UNC Workgroup Report

UNC 0607S:

Amendment to Gas Quality NTS Entry Specification at the St Fergus NSMP System Entry Point

Figure 3: 'Heat map' for BP scenario 1

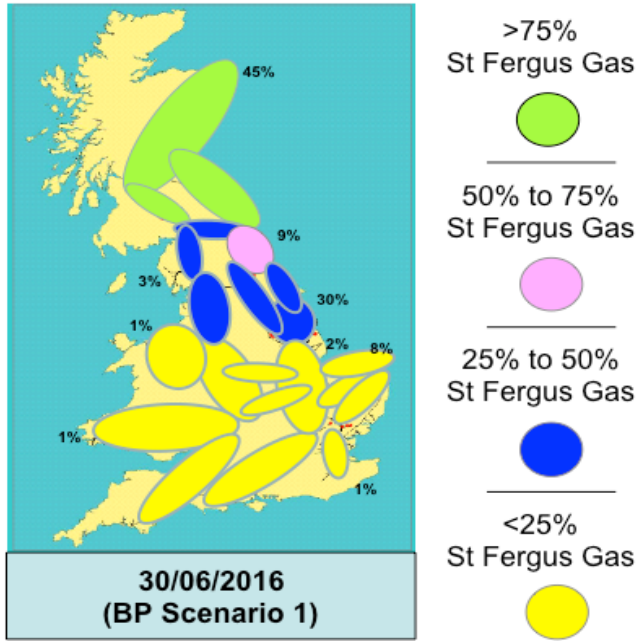
In respect of the BP scenarios, National Grid NTS were also asked to provide a 'heat map' analysis; to determine the risk of high CO₂ gas entering the NTS and how far any out of specification flow might then be expected to reach. The Workgroup also requested that the analysis contained information about the assumed distribution of supplies, where the gas would blend on the NTS and the NTS flow patterns.

The first 'heat map' (see [Figure 3](#)) shows the penetration of aggregate flows of St Fergus gas into the NTS, assuming entry flows are equal to those presented in BP's analysis, [scenario 1](#) (selected because this contains the highest flows of all BP scenarios and is thus a 'worst case' from the BP scenarios):

Figure 4: 'Heat map' for BP scenario 4

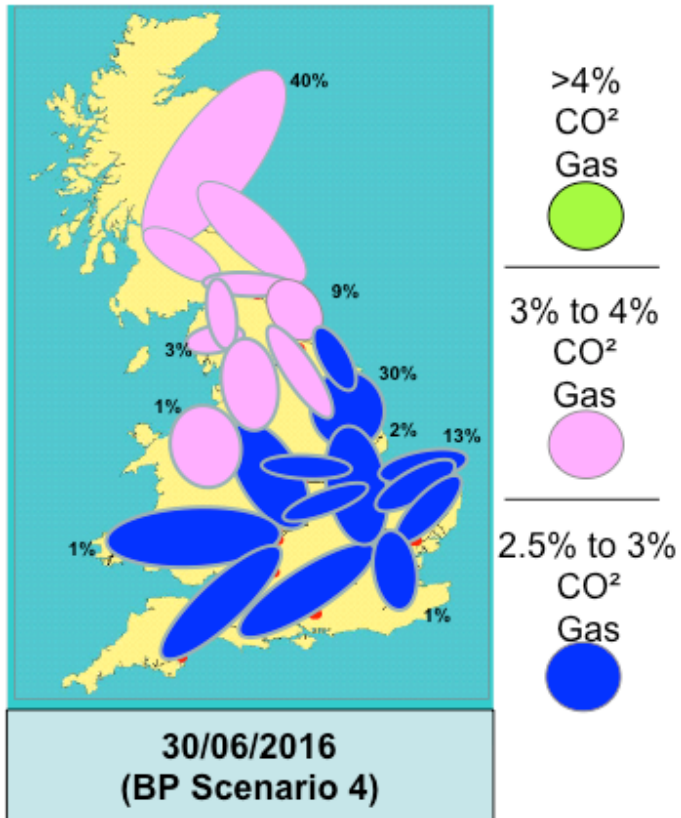
The second 'heat map' schematic (see [Figure 4: 'Heat map' for BP scenario 4](#)) shows the levels of CO₂ on the NTS, assuming St Fergus sub-terminal flows and CO₂ content are equal to BP's scenario 4 (giving a 'worst case' CO₂ entering the NTS from the four BP scenarios). This scenario shows a blend of 3.87% CO₂ entering the NTS, therefore no NTS direct connect receives any gas in excess of 4%.

Figure 5: Carbon Dioxide vs Wobbe Index

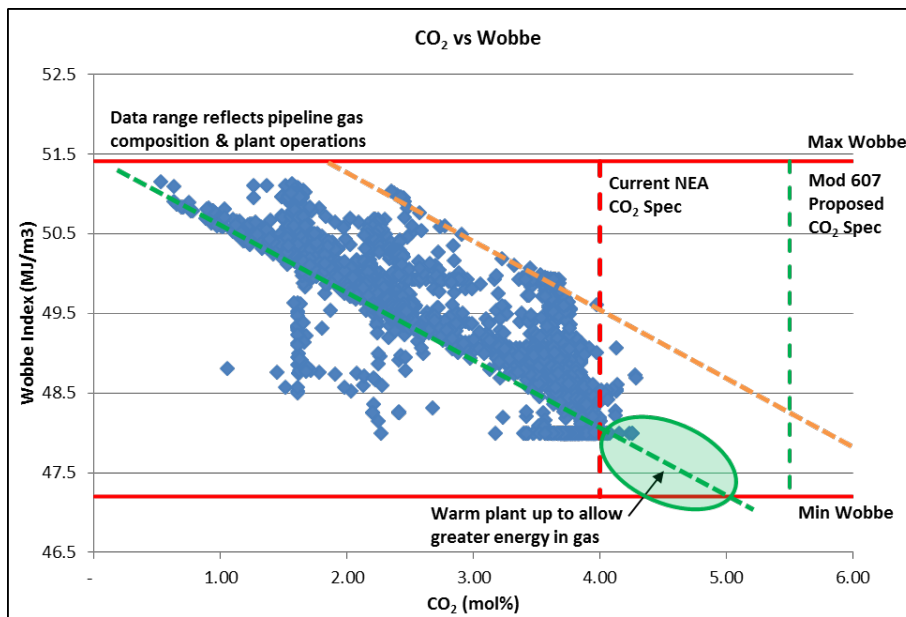
The Workgroup requested that analysis be performed on the consequential impacts of increased CO₂ on other gas quality parameters. The St Fergus terminal operator provided correlations of CO₂ content with other NEA Specifications in the gas delivered to the NTS from the FUKA pipeline. The CO₂ content of the processed gas from the FUKA pipeline has been correlated with several GS(M)R parameters measured at the same time (namely, WOBBE, Gross Calorific Value (GCV), Incomplete Combustion Factor (ICF) & Soot Index (SI)). The specification of processed gas from the FUKA pipeline is measured "stand- alone" before commingling with Vesterled gas and is upstream of the NTS compressor station. The data includes certain short-duration periods when blending with Vesterled gas was required due to higher CO₂ concentrations in FUKA pipeline (as per the current blending arrangements). See [Figure 5](#) for correlation of CO₂ with Wobbe Index.

In summary, the historic data analysed reflects variations in pipeline gas composition and also plant operation. An increased CO₂ content of FUKA gas reduces Wobbe and (to some degree) GCV of redelivery gas. Higher CO₂ content gas may need to be managed by adjusting the processing plant operation (warmer plant) to reflect the pipeline gas composition and ensure the export gas meets the lower Wobbe specification.
